OMaouter definition ambiguity

Addressing comments #171, 172, 173, 181 of IEEE 802.3 dj draft 2.1

Laurent Alloin, Amitkumar Mahadevan, Karen Liu
Nubis Communications

Figure 180–5—Transmitter $\text{OMA}_{\text{outer}}$ each lane versus $\max(\text{TECQ}, \text{TDECQ})$ and receiver sensitivity ($\text{OMA}_{\text{outer}}$) each lane versus TECQ

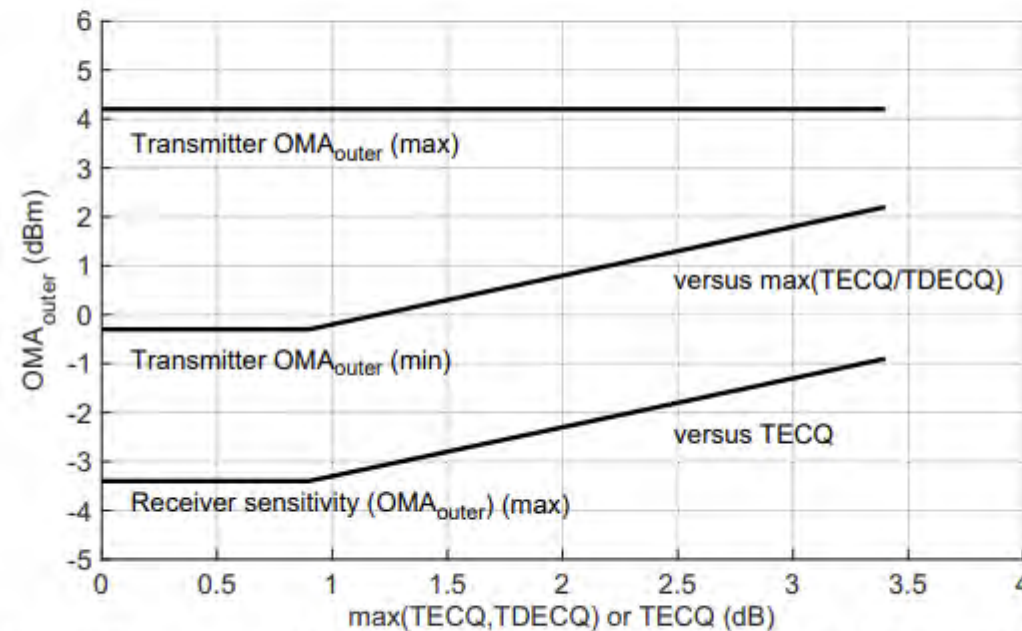
For Link budget calculation, it is ambiguous whether the $\text{OMA}_{\text{outer}}$ considered is measured “before the reference equalizer” or “on the equalized signal”

Since $\text{OMA}_{\text{outer}}\text{-TDECQ}$ is understood as the “usable” OMA of the TX as seen by the reference RX, both quantities need to be defined consistently.

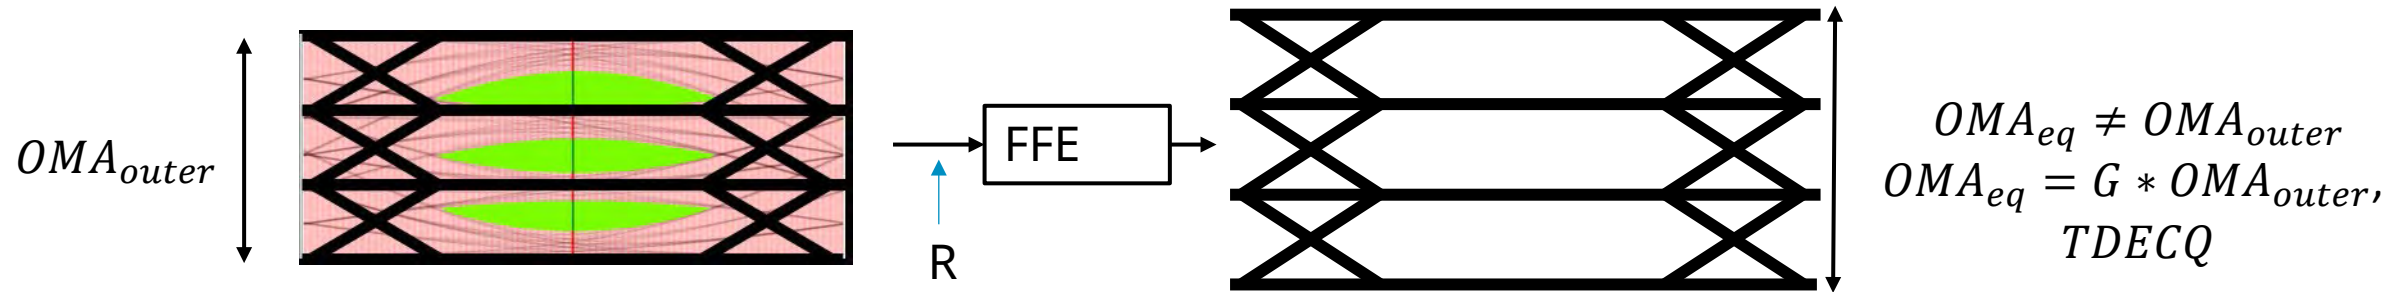
3 modules characterized with different OMAouter/ER “before the reference equalizer” or “on the equalized signal”

⇒ 1 dBm of OMAouter-TDECQ difference, as currently defined

⇒ Consistent definitions lead to difference <0.2dBm

⇒ 1.2dB of difference of TDECQ
⇒ closer to 0.2dB after normalization to “unequalized OMAouter”

⇒ Similar sensitivity

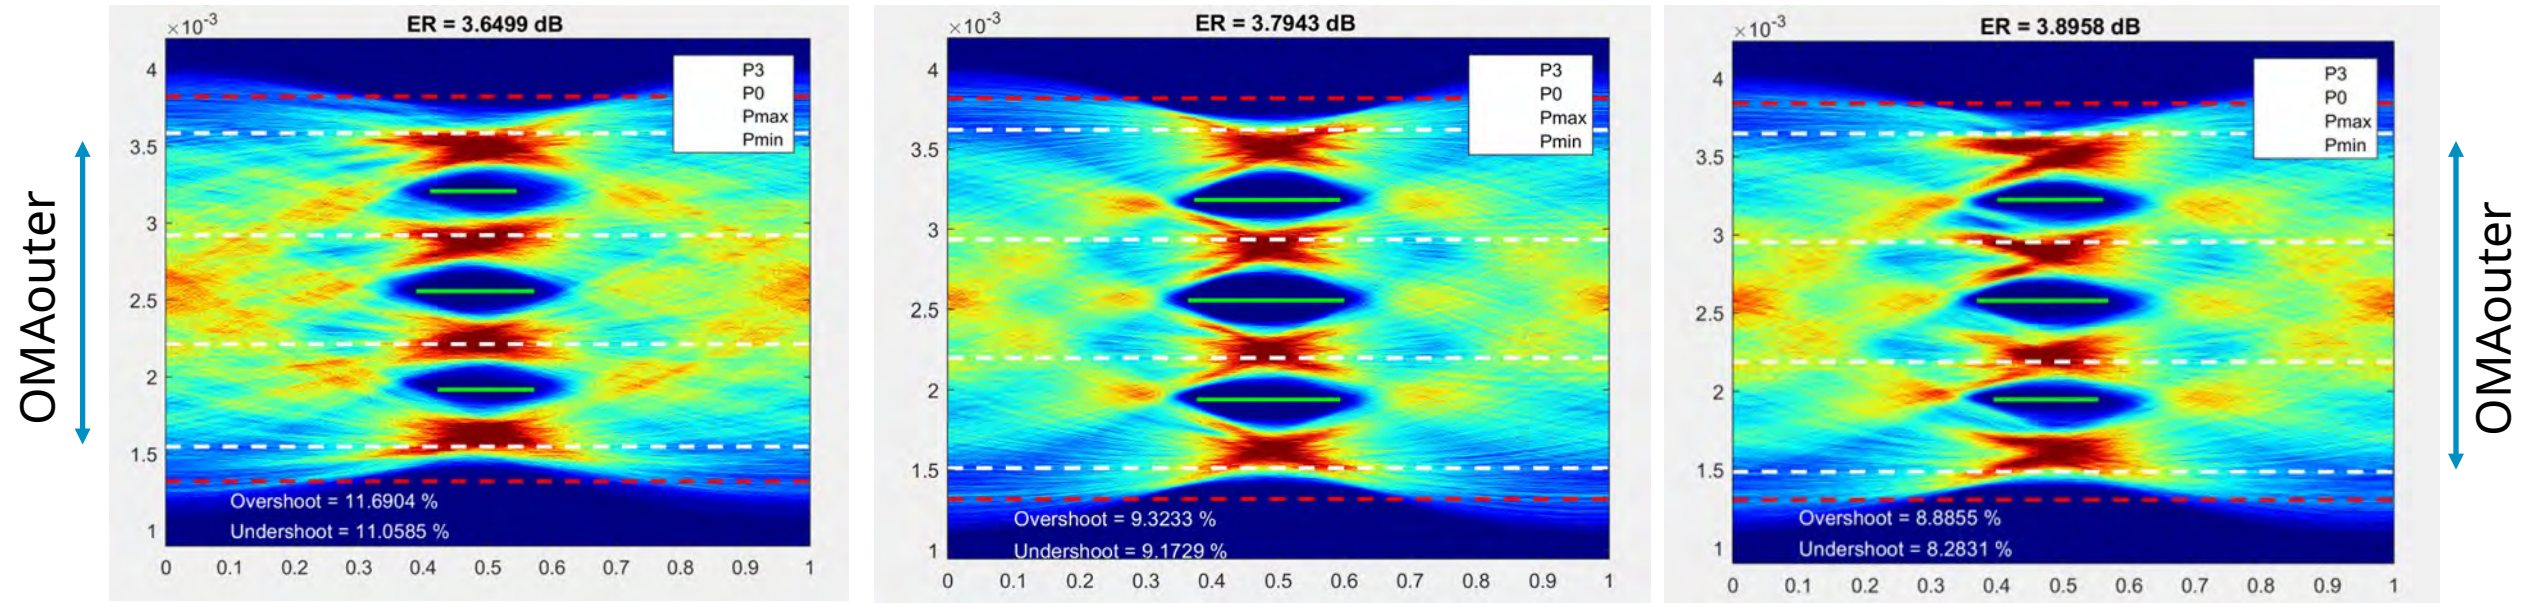
OMAouter is not “always” a good metric of the signal power associated with the link budget
Below, OMAouter is measured at position 2/3 in runs 6/7 of prbs13Q after BT filter

Signal power and OMAouter levels are consistent across modules

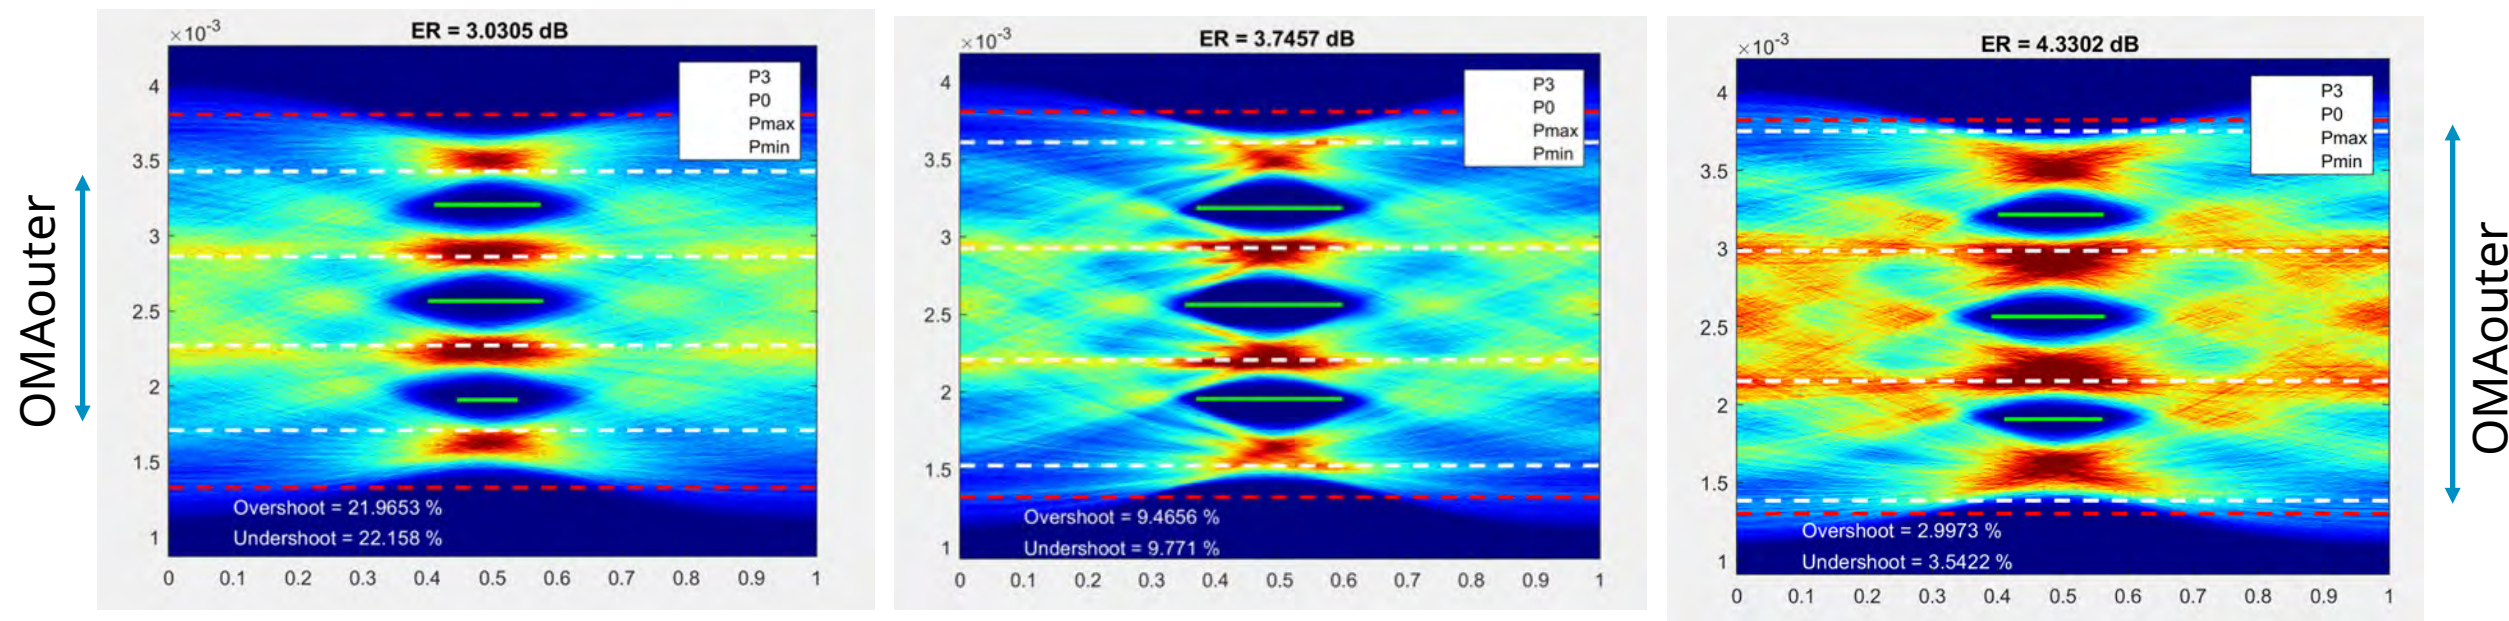
OMAouter is not “always” a good metric of the signal power associated with the link budget
Below, OMAouter is measured at position 12 on SSPRQ sequence after BT filter

While Signal power levels are consistent across modules, estimated OMAouter levels are not !

Possible reconciliations

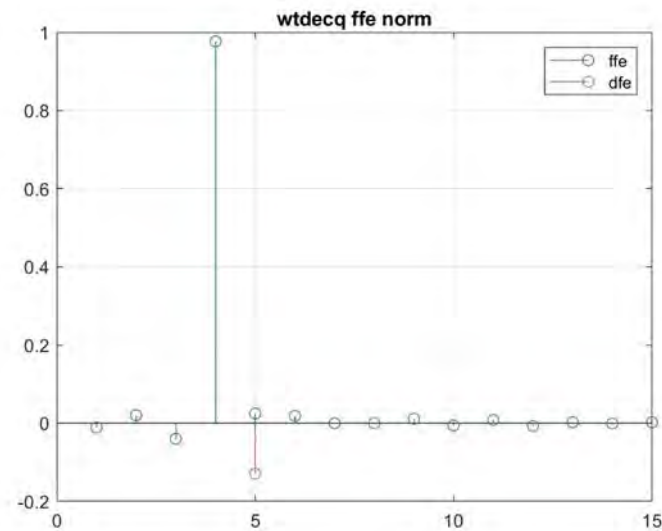
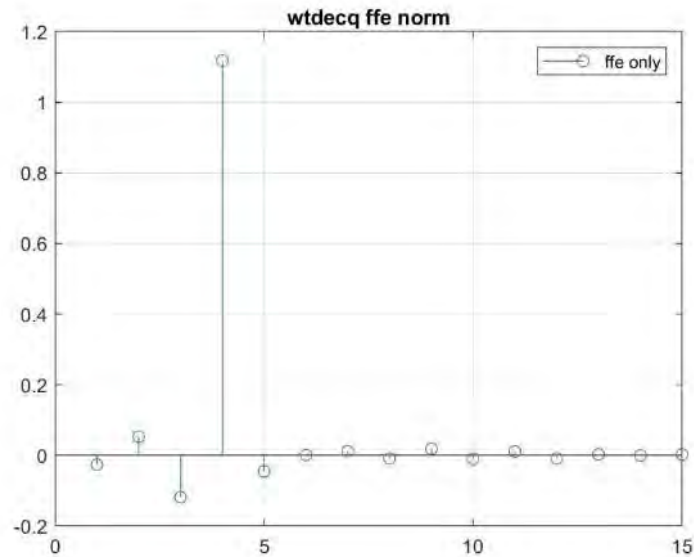
- A. Perform OMA_{outer} measurement 12 UI after step on un-equalized signal in sequence of length 15. Problem: PRBS13Q has length of 0s/1s of duration 6/7 only – SSPRQ has length of 0s/1s of duration 14 only
- B. Use OMA_{outer} measured on the unequalized signal in TDECQ metric computation (formula 121-12).
- C. Use OMA_{eq} –TDECQ, but be mindful that OMA_{eq} by itself is not a good proxy for signal power in the link budget anymore!
- D. Report (OMA_{eq}, TDECQ) **normalizing equalizer taps power to unity**, and use OMA_{eq} as substitute to OMA_{outer} in link budget
- E. Report (OMA_{eq}, TDECQ) **normalizing signal power at input of FFE**, and use projected OMA_{eq} w/o C_{eq} adjustment as substitute to OMA_{outer} in link budget

Options A, B, C assumes normalizing sum of FFE taps to unity, as in “current scheme”.

Options D, E would normalize differently the FFE taps and is a more meaningful resolution.

Option B approaches a similar result as Option E, provided OMA_{outer} \approx OMA_{eq} in option E.
